Sub: TANGEDCO - Uppur Thermal Power Project (2 x 800 MW) –
Environmental Clearance Sought For – Additional details
submitted

Uppur Thermal Power Project (2 x 800 MW)
Meeting of the Thermal Expert Appraisal Committee of MOEF/GOI
held on 25.6.2015

Point wise reply for queries raised by the EAC

Photos of Uppur TPP

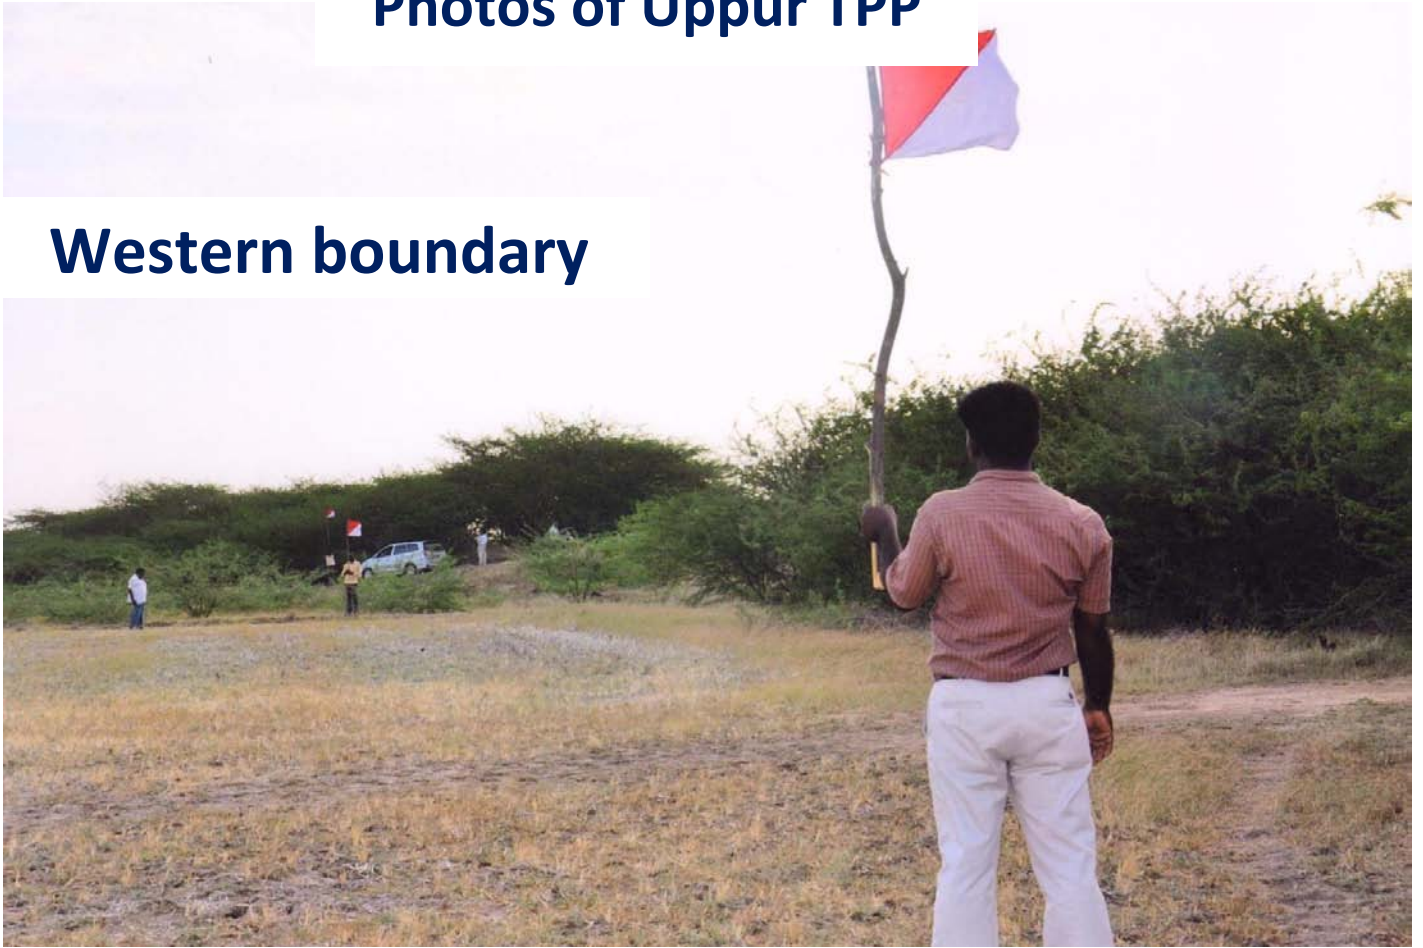
Point 1: Pictures and location of the creeks in a legible map

Photographs of the project area and creeks nearby are enclosed as Annexure -1. Further, a detailed map indicating all the tanks, creeks, mangroves, etc., located near the project area has been prepared and enclosed as Annexure - 2.

CRZ Mapping for the Proposed Uppur Thermal Power Project (2 x 800 MW), Tiruvadanai Taluk, Ramanathapuram District

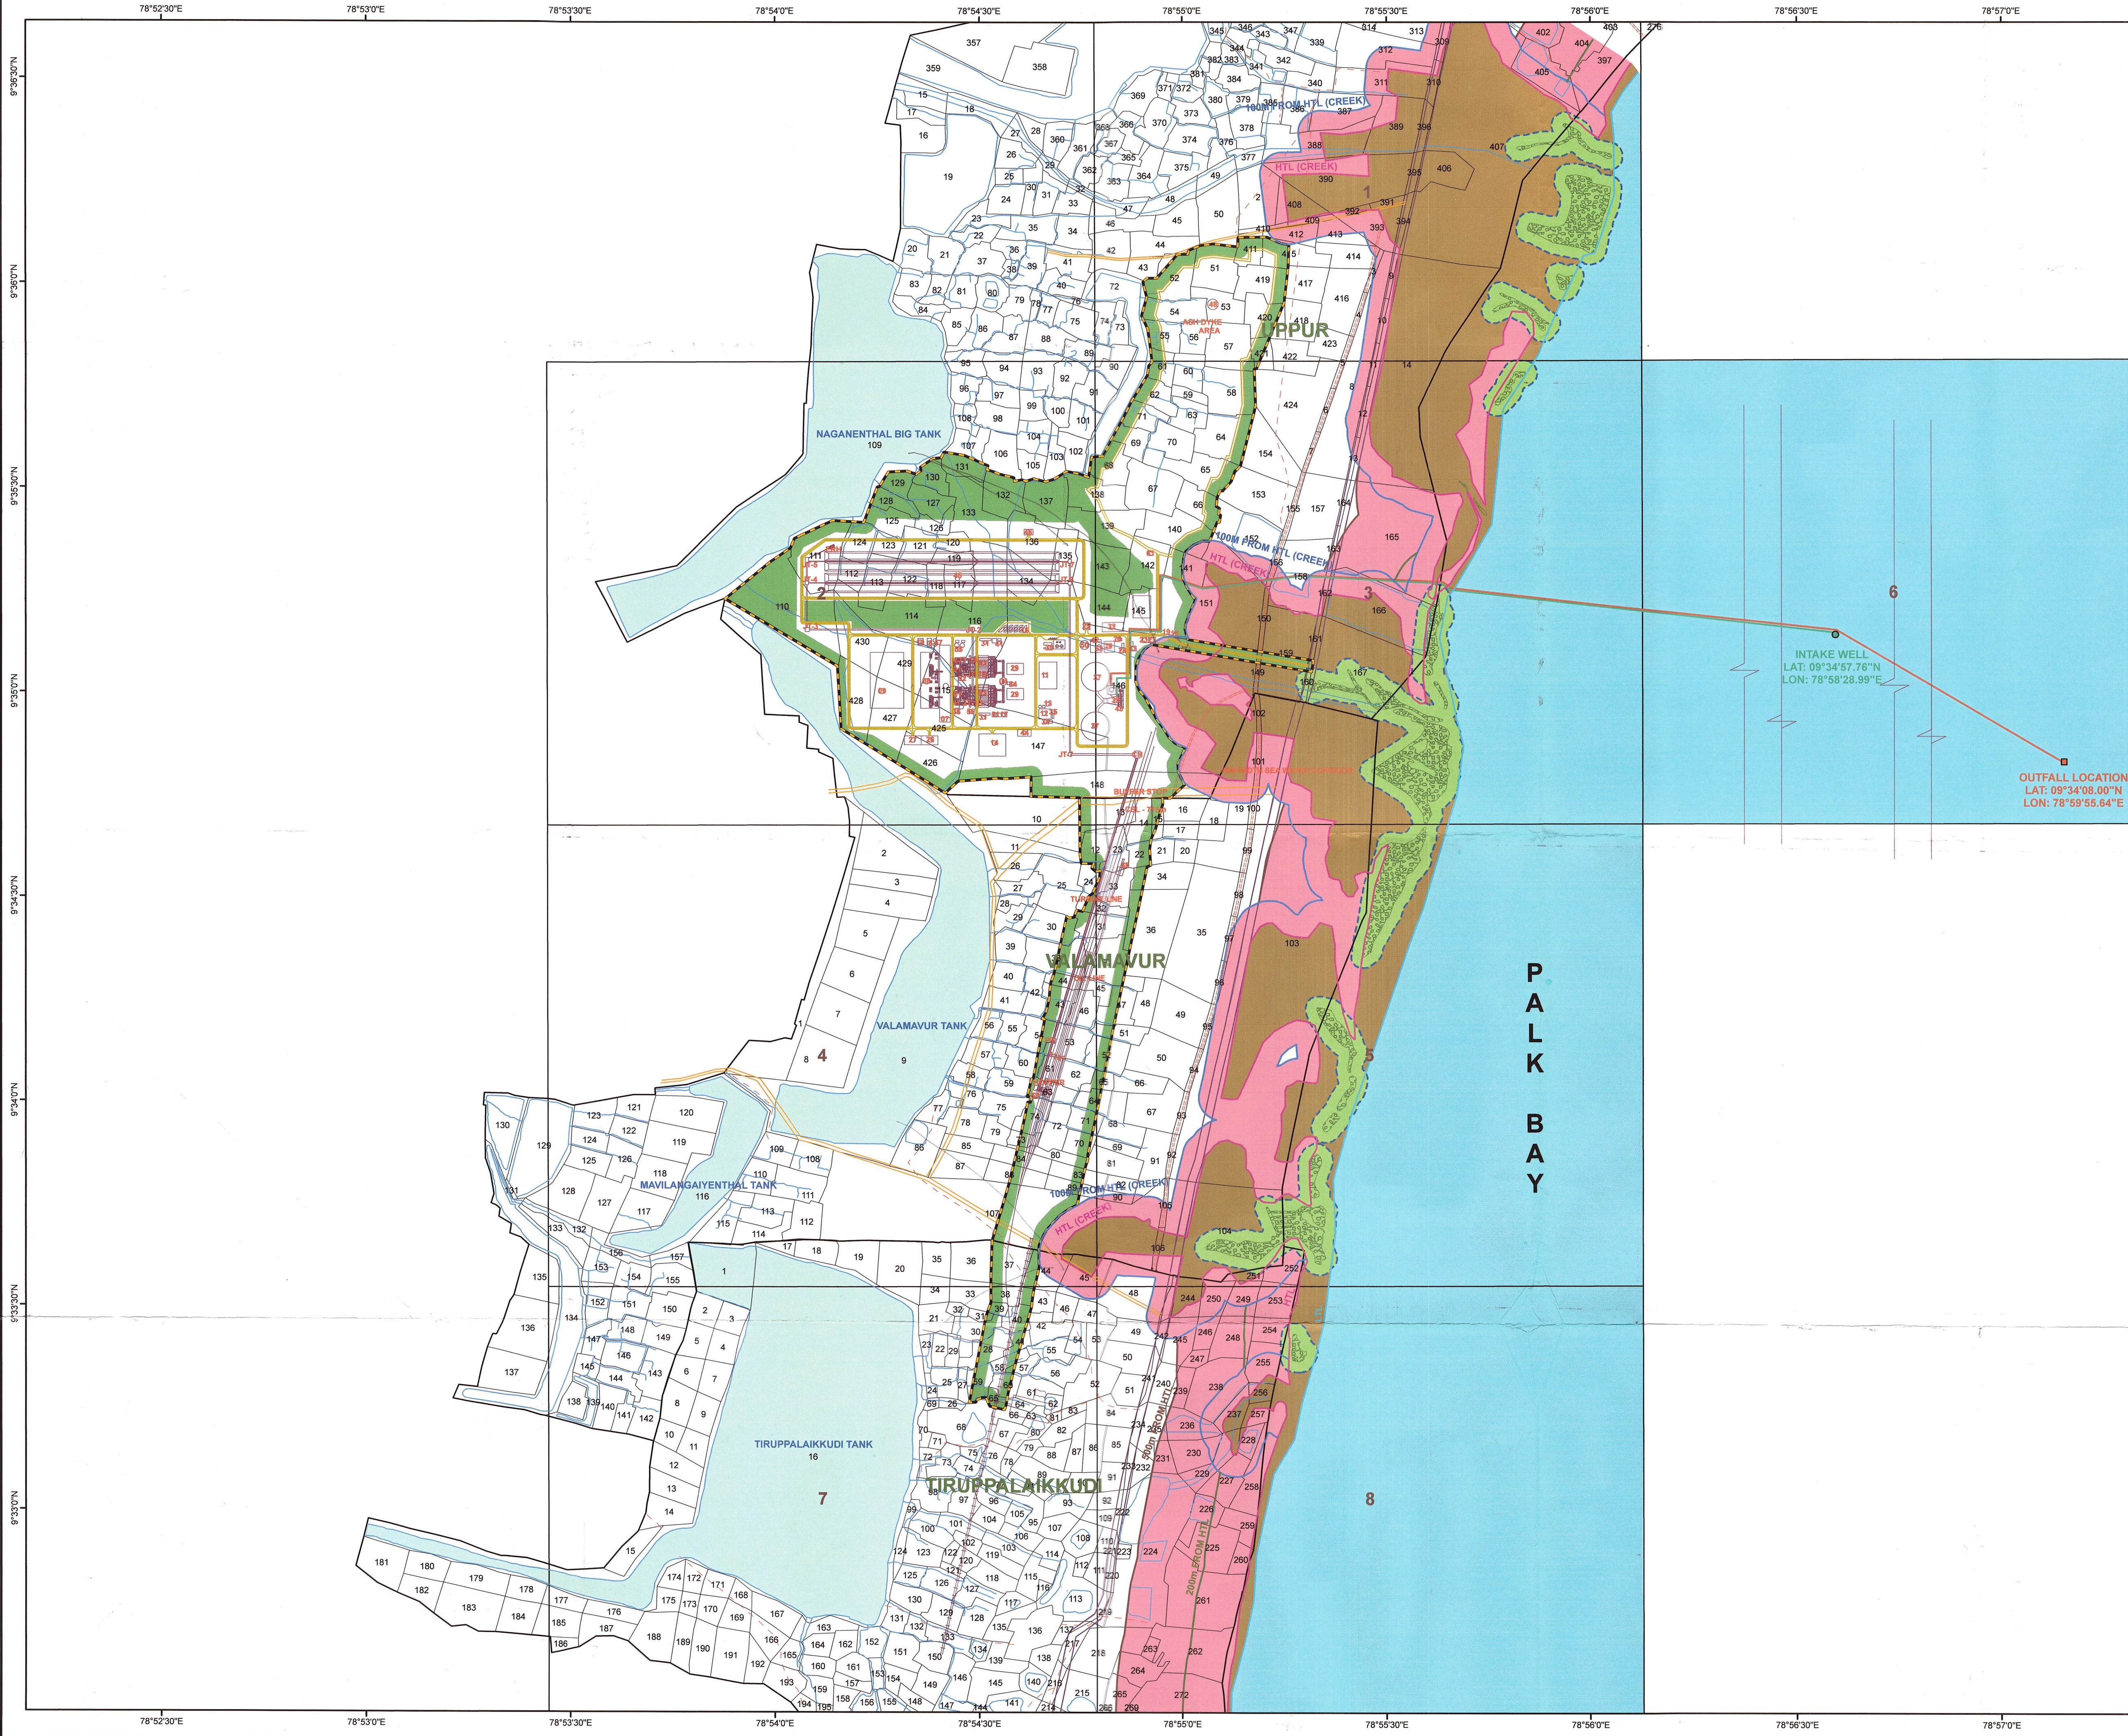
18. In order to maintain tranquility and sanctity of the creek area by ensuring bare minimum disturbances, proposed sea-ward pipe line shall have to be realigned.

As directed by EAC/MOEF, the sea water pipe line has been realigned such that there is no disturbance to the Mangroves. The route has been superimposed on the CRZ map, through Institute of Remote Sensing, Anna University. As per the revised alignment, the Outfall is located at 8.1 KM from Shore at a depth of 5.5m (earlier located at a distance of 7 KM) and the Intake well is located at a distance of 5.3 KM at 4.0m depth (earlier located at a distance of 5 KM).

| TITLE | PLOT PLAN (PLANT AREA) | | |

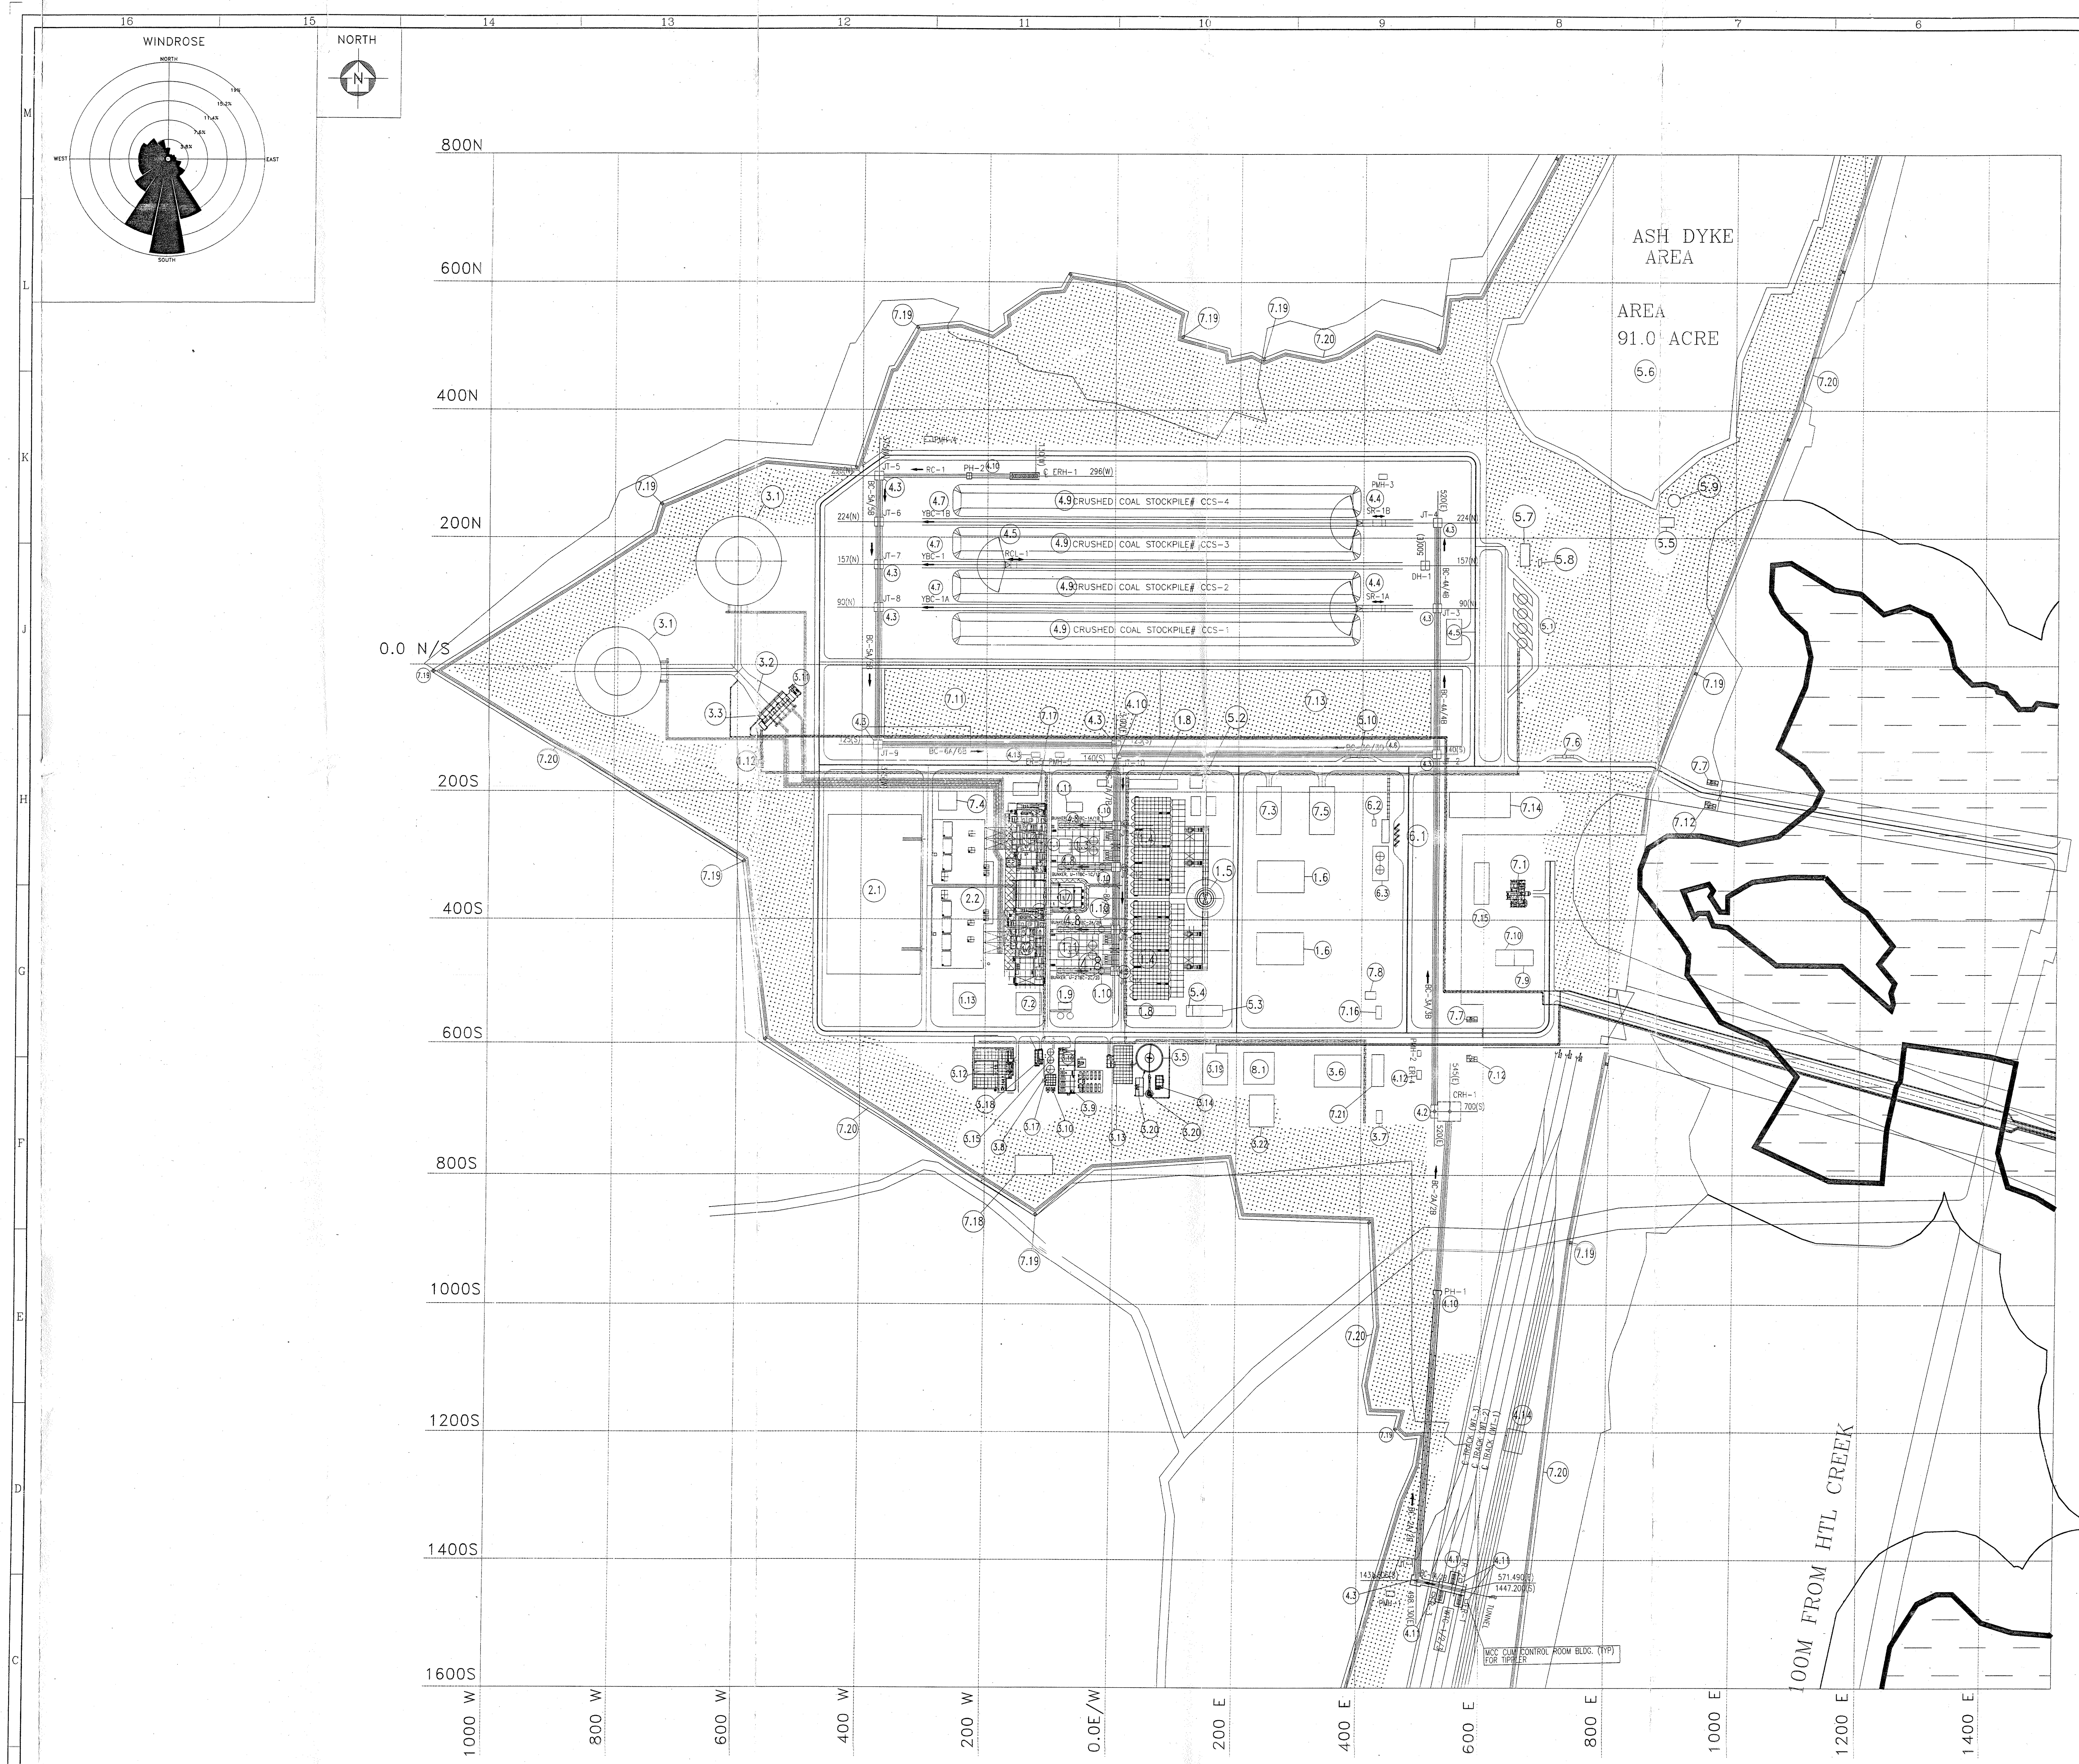
Point 3: Revised layout clearly depicting the various Units and facilities

Revised layout clearly depicting the various units and facilities has been prepared through Institute of Remote Sensing, Anna University, showing the revised cooling water intake and outfall route is enclosed as Annexure-2. A blow up of the Power Plant layout clearly depicting various units and facilities is enclosed as Annexure - 3

Figure 9. Study area with new surplus canals

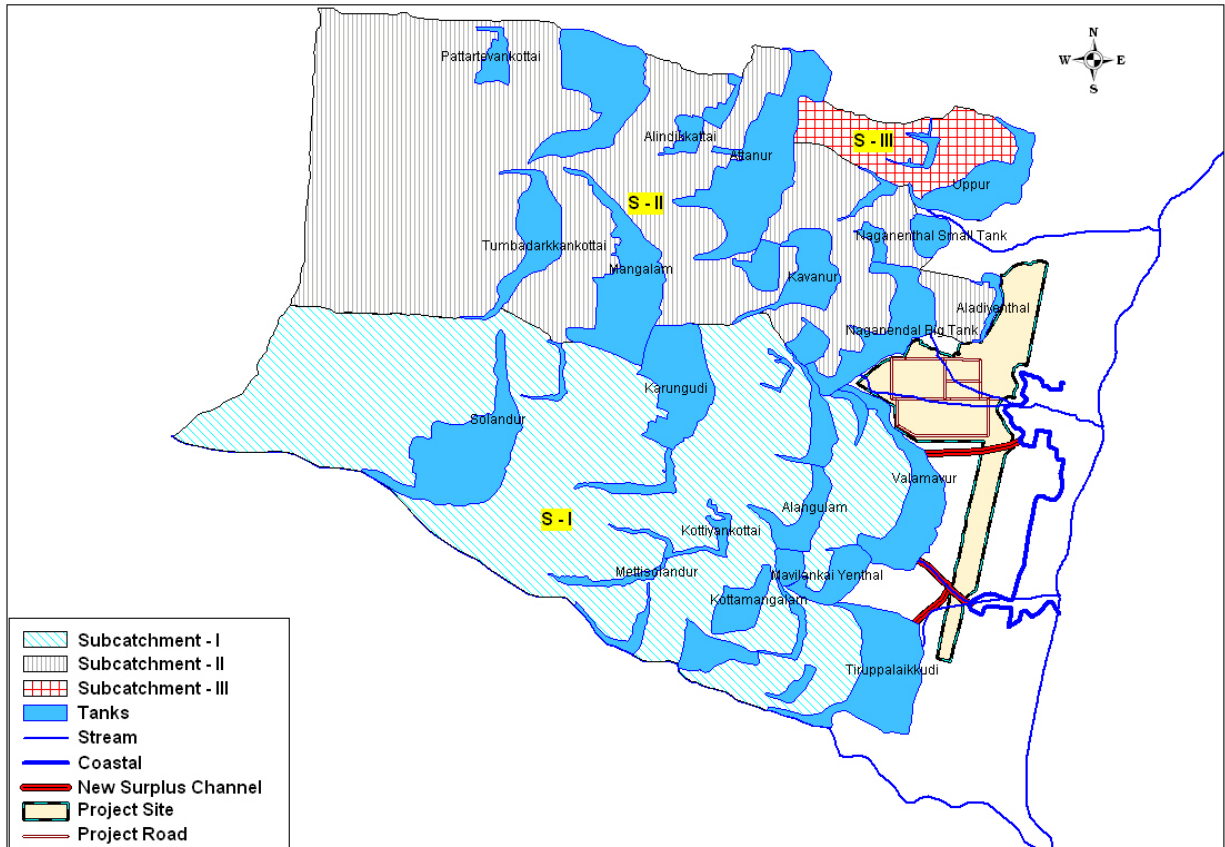
Point 10: Diversion of existing Nalags shall be done in such a way that it shall not dry up the creeks and it shall be ensured that water flows perennially in the creeks so as to preserve the mangroves. Anna University, who has conducted the hydro-geological study, shall present the same in the next meeting

As directed by the Committee, the surplus channels have been diverted in such a way so that it flows back to its natural course downstream after crossing the Power Plant area to maintain the ecosystem balance on the downstream side. The report on the realignment of the surplus channel, is enclosed in Annexure – 6.

In order to discharge the surplus discharge, without affecting the functioning of power plant, new surplus canals are designed. The new surplus canals are originating at the corresponding tanks and confluences at the natural drainage available at the downstream. For designing purpose, existing slope between the two points (starting and confluence points) is used as the bed slope to be provided for each canal. The new surplus canals are marked in the map and presented in Figure 9. The length of each canal is calculated with the help of GIS.
